RIVERBEND CROSSING

EARLY GRADING PLAN

EPC STORMWATER REVIEW COMMENTS
IN ORANGE BOXES WITH BLACK TEXT

RIVERBEND CROSSING
FILING NOS 1 & 2
GRADING & EROSION
CONTROL PLAN

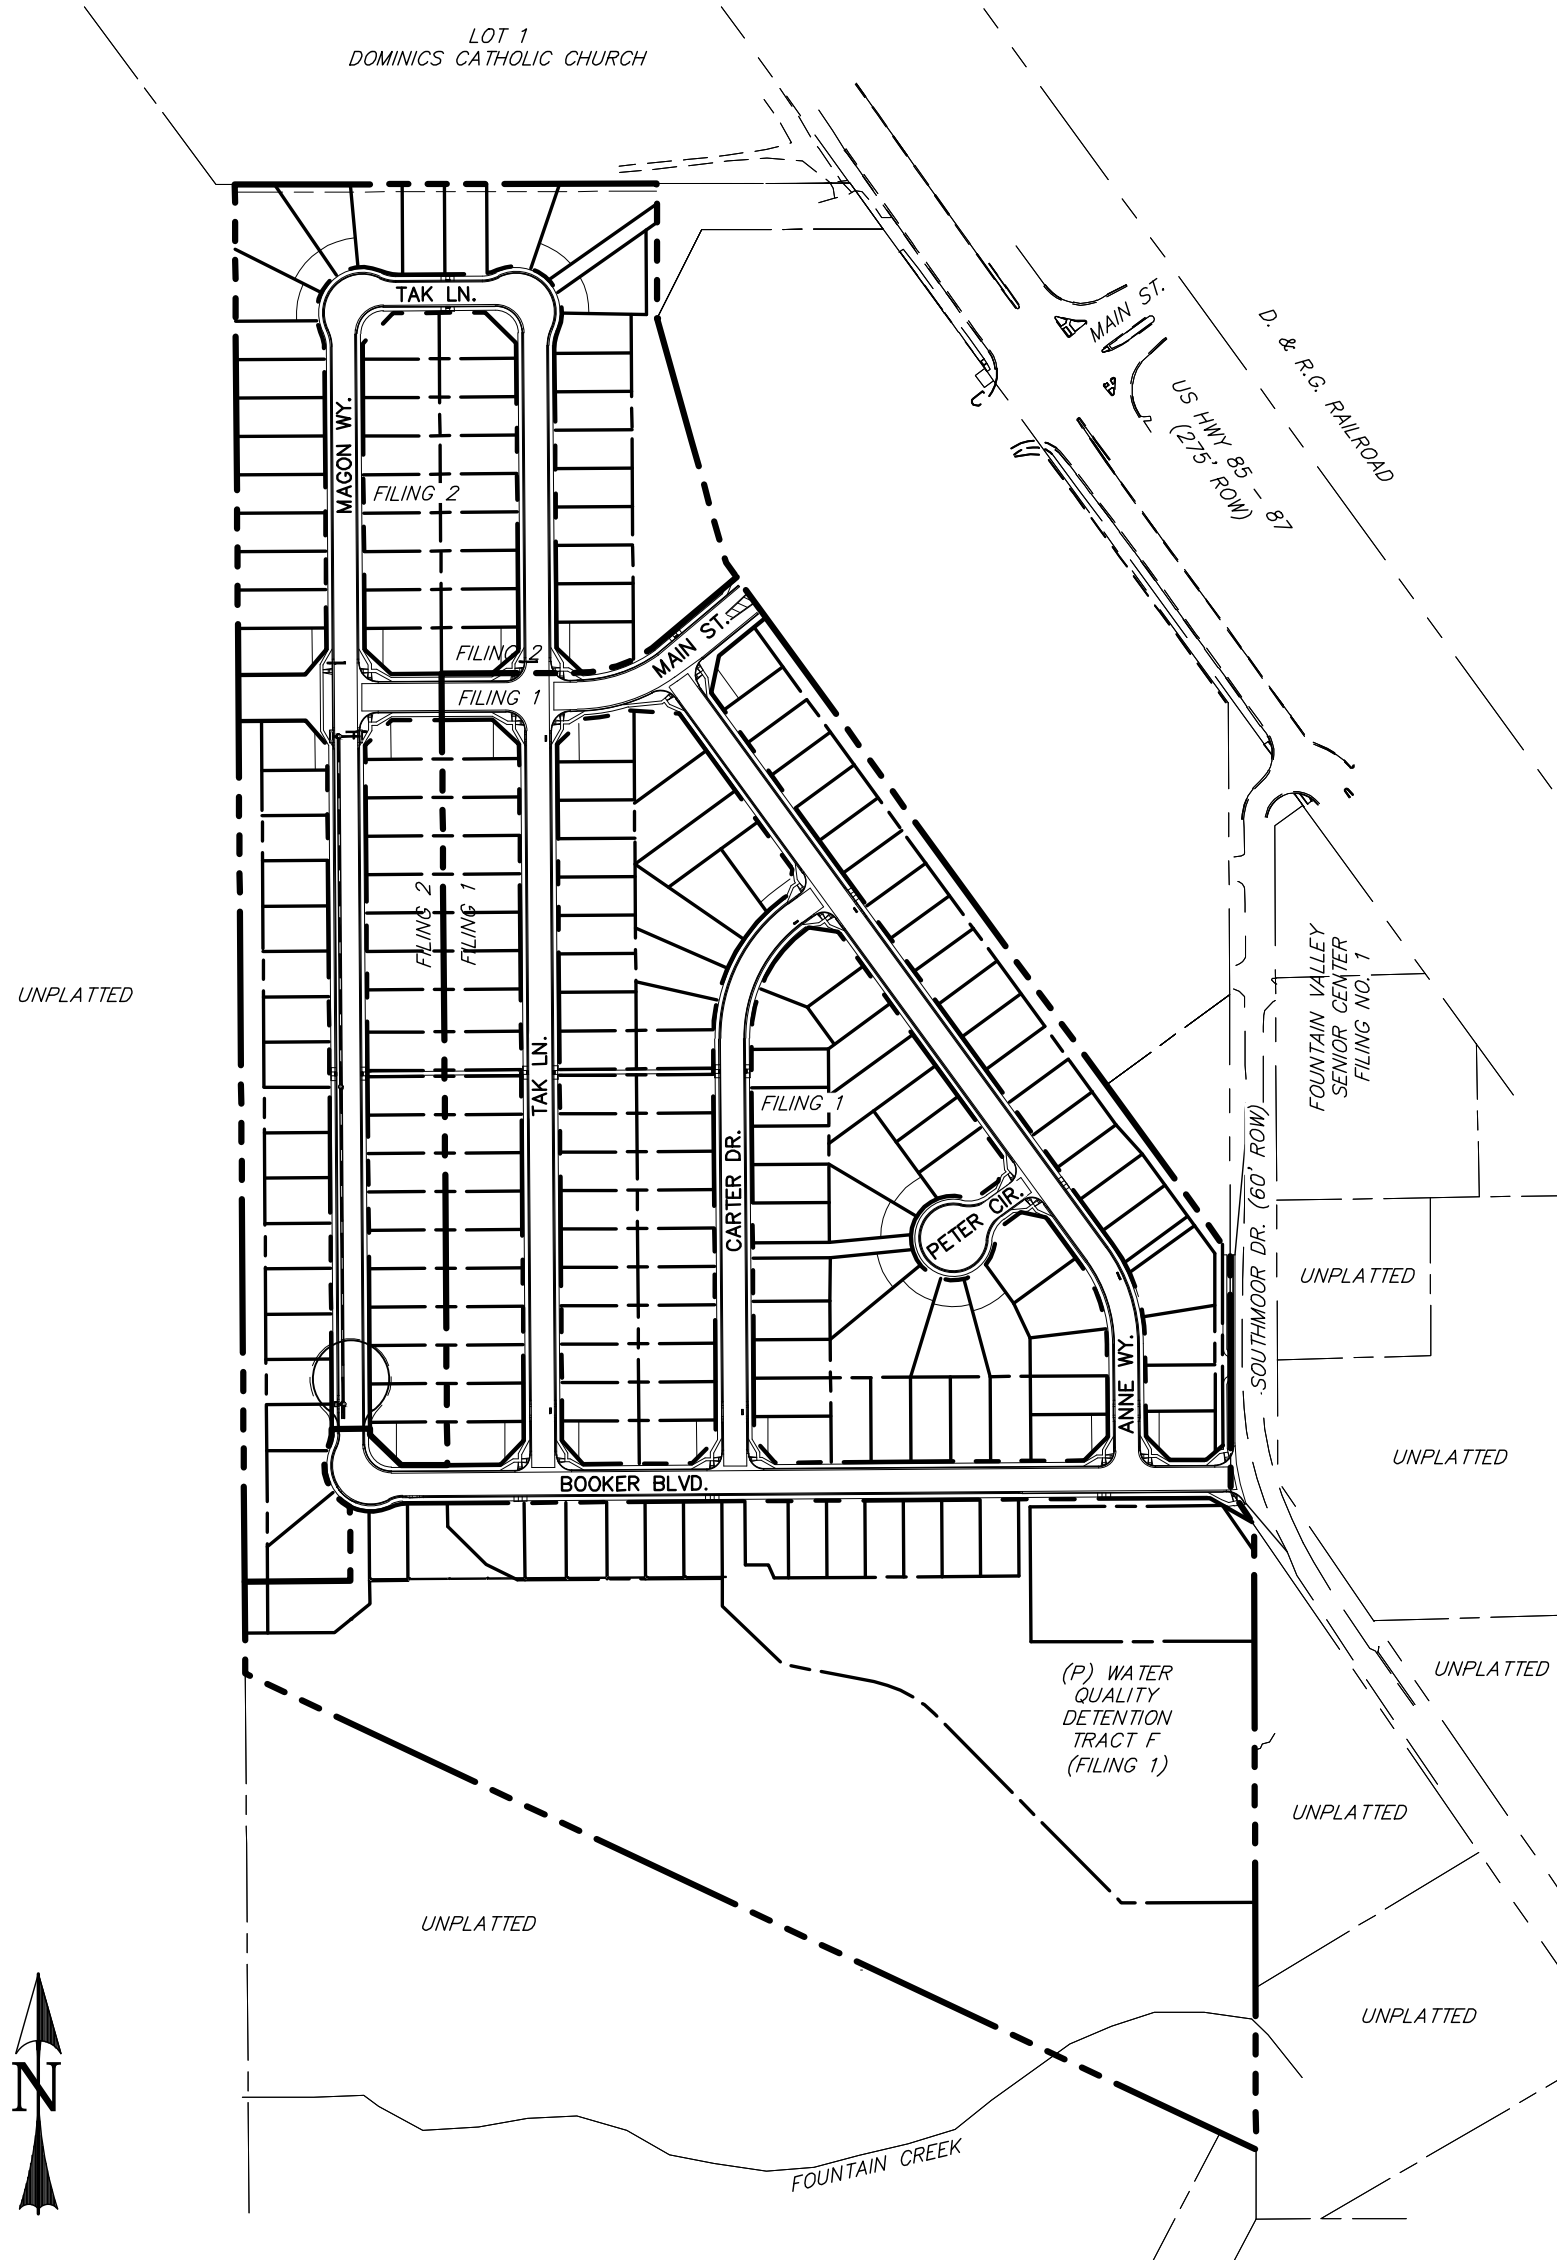
Fill in the Blank.
Unresolved.

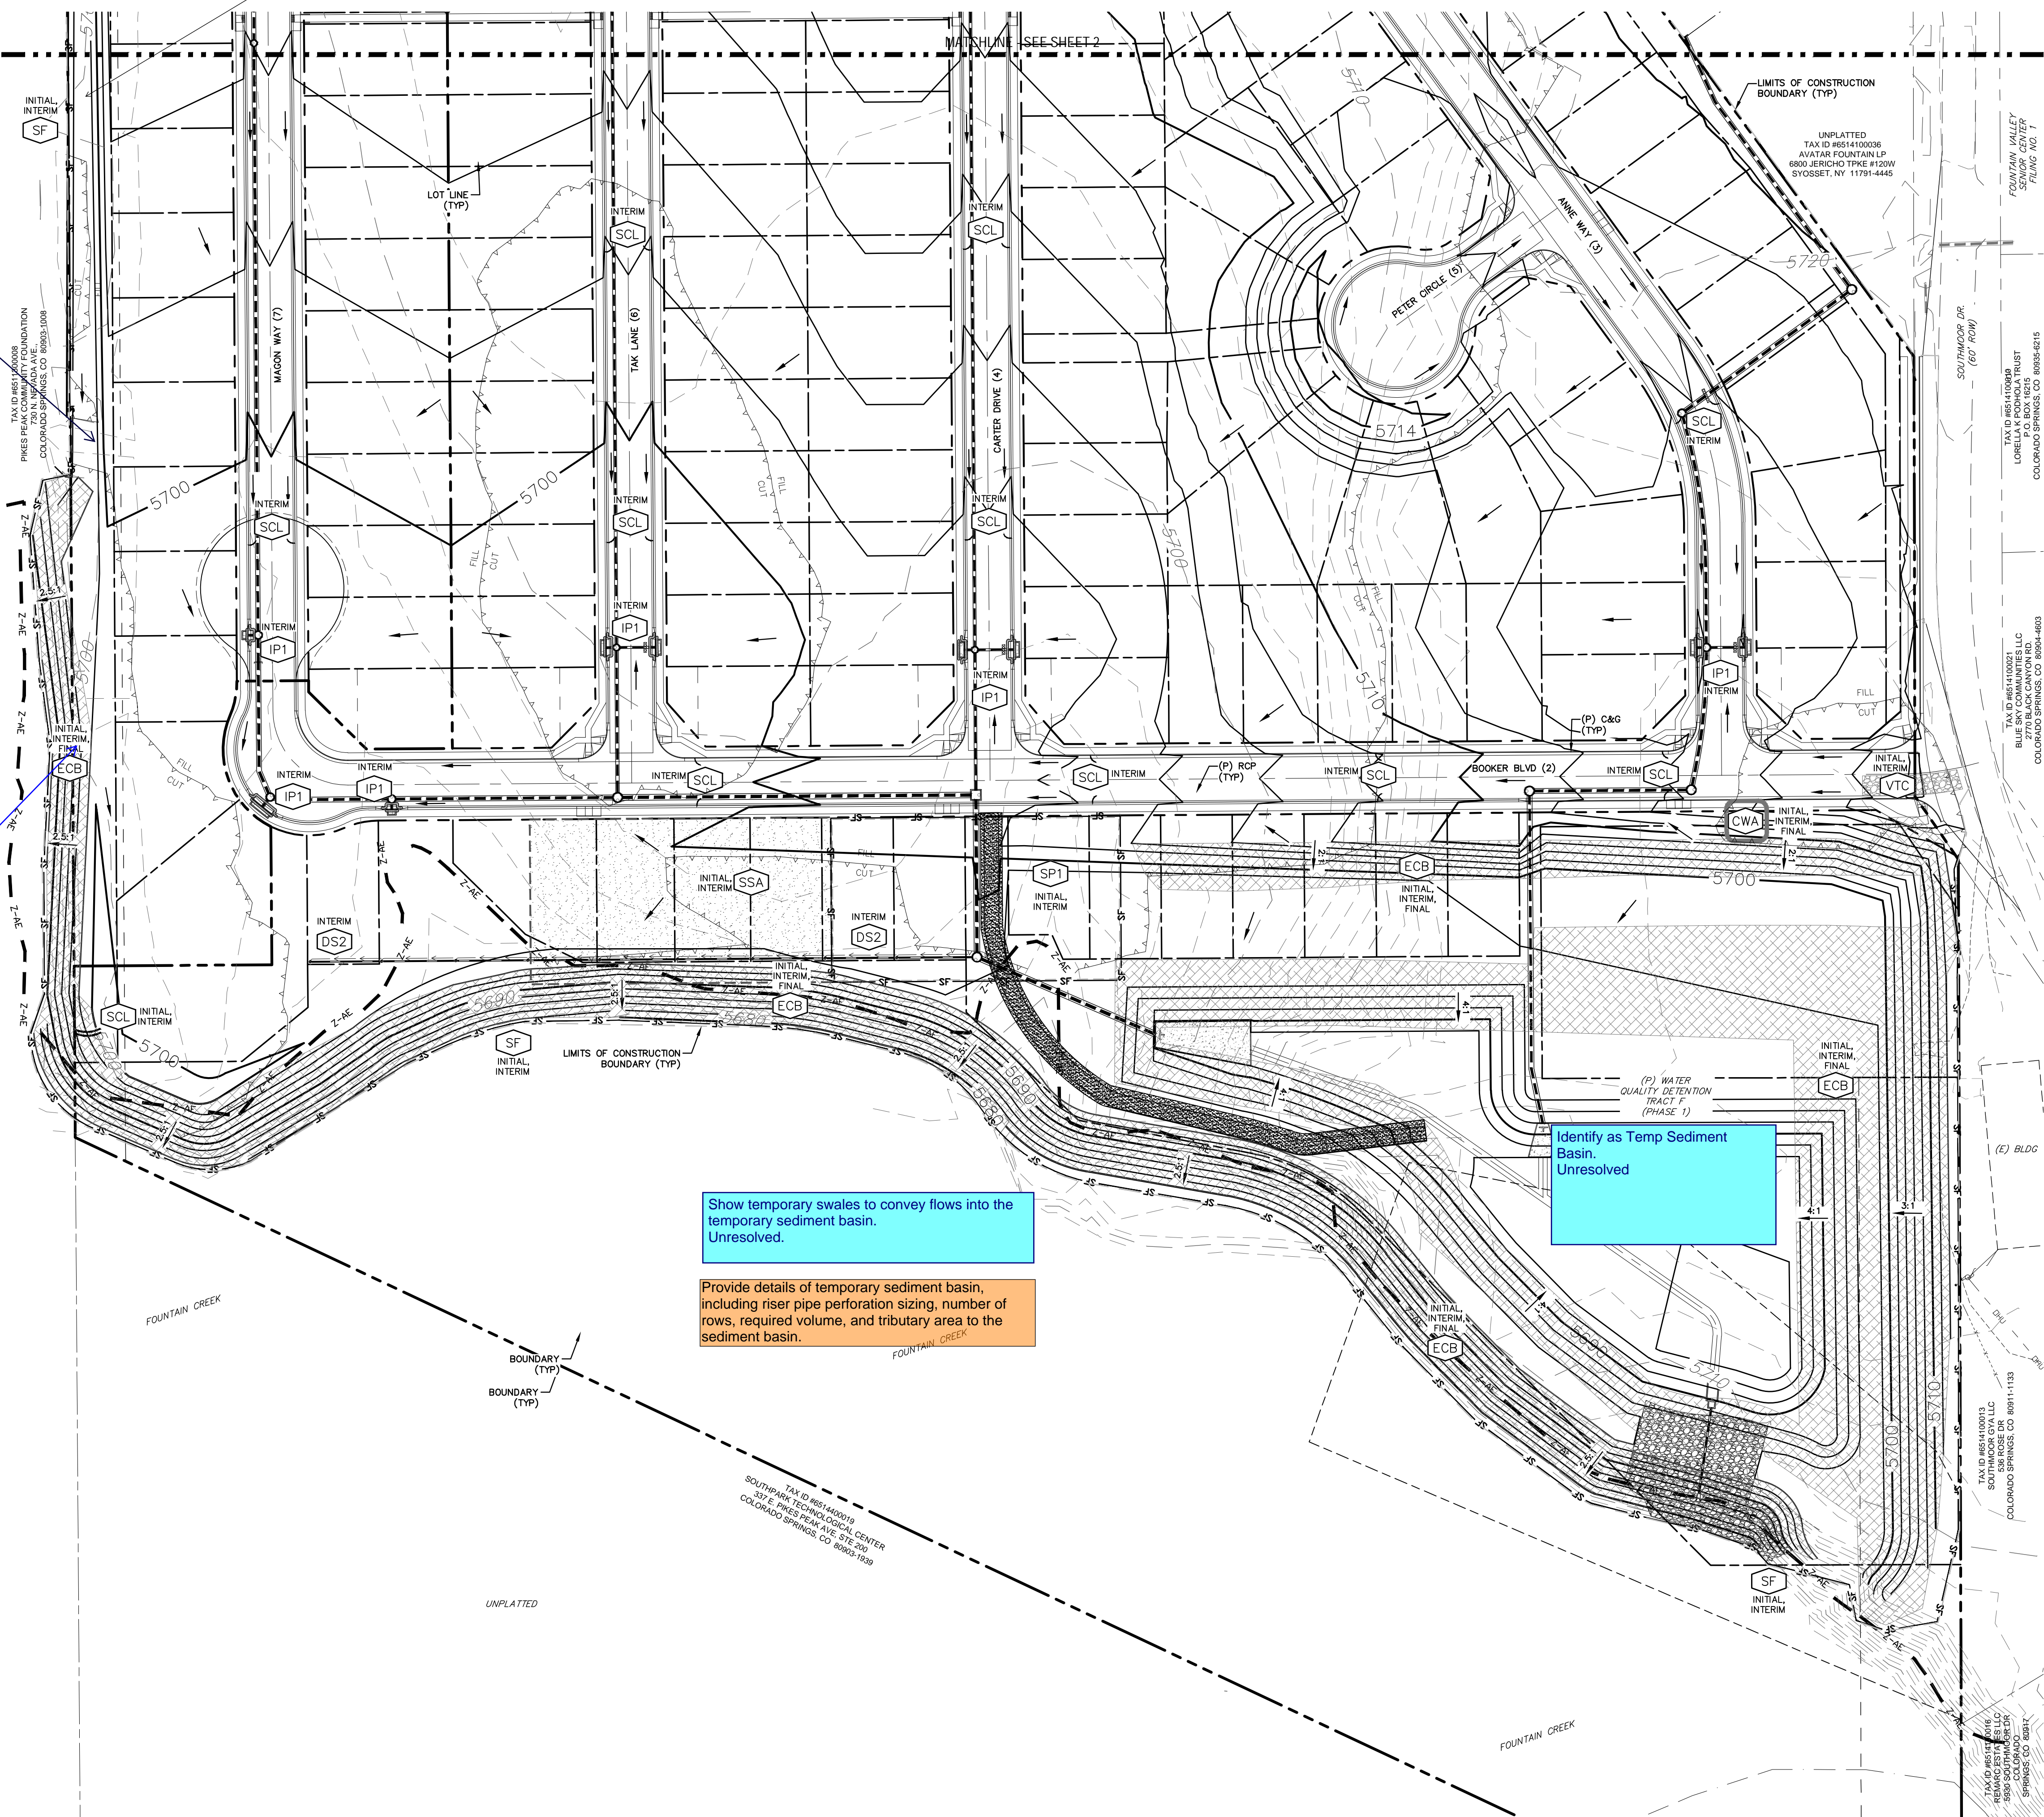
Need owner permission to grade offsite. Provide copy of owner permission to EPC. Unresolved.

Silt fence is not a sufficient BMP for the concentrated flows routed by the channel. Revise. Unresolved.
